APPLICATION NO.	FILING DATE	FIRST NAMED INVENTOR	ATTORNEY DOCKET NO.	CONFIRMATION NO.
10/821,395	04/09/2004	Jeff Bremmon	3156.15US02	8441

Office Action Summary

This is the first Office Action for application number 10/821,395 Flat Panel Display Mounting System, filed on 4/9/04. Claims 1-25 are pending.

PITCH-ADJUSTABLE WALL MOUNTS

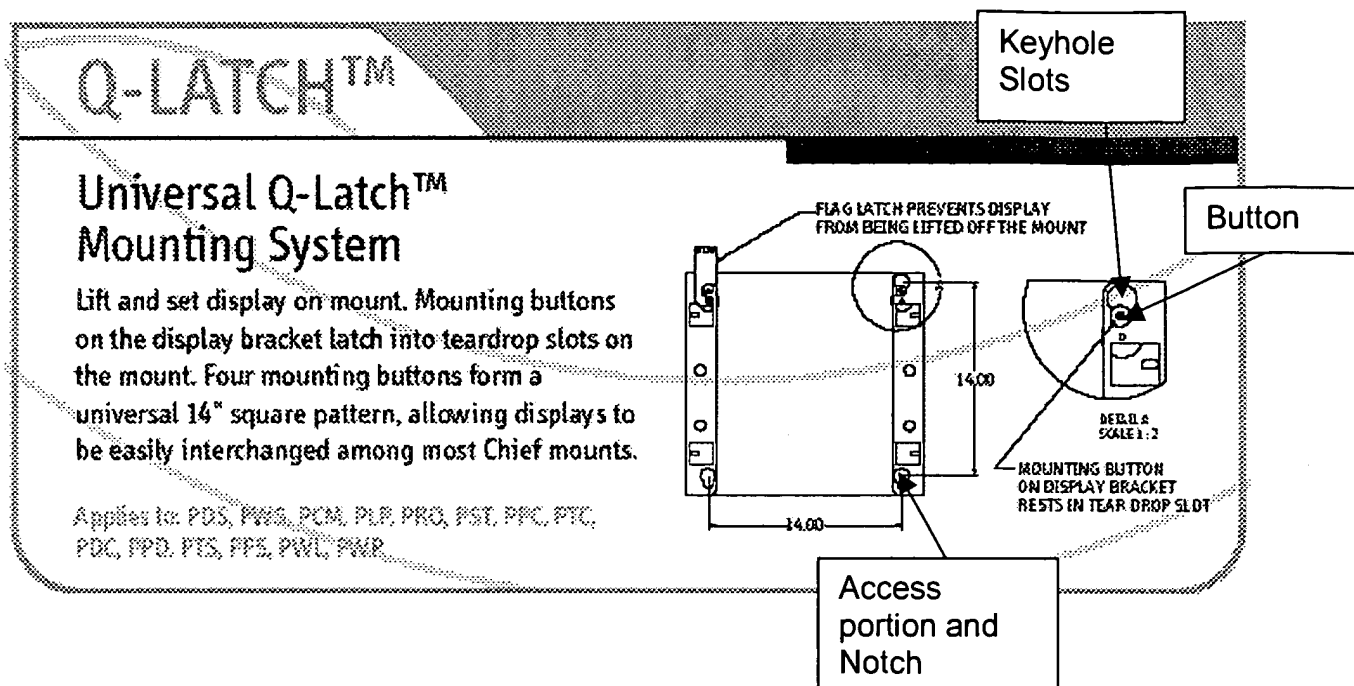
The Q-latch Brochure (See Marked Drawing Below for rejection) discloses applicant's basic inventive concept including teaching a flat panel display and a mounting system having first and second bodies, wherein the first body has a display connecting portion having a plurality of keyhole slots arranged in a polygonal pattern that are spaced a substantially equal distance from each adjacent keyhole slot and are defined therein as having an access portion and a notch. Curtis et al. discloses that the second body has a plurality of fastening buttons.

The Q-latch Brochure shows wherein the second body has an adjustable mounting system and wherein the flat panel display can be selectively interchangeably oriented in at least a horizontal and a vertical orientation.

Adjustable body

Mounting System

Flat Panel Display

1st and 2nd Bodies/ may be defined interchangeably
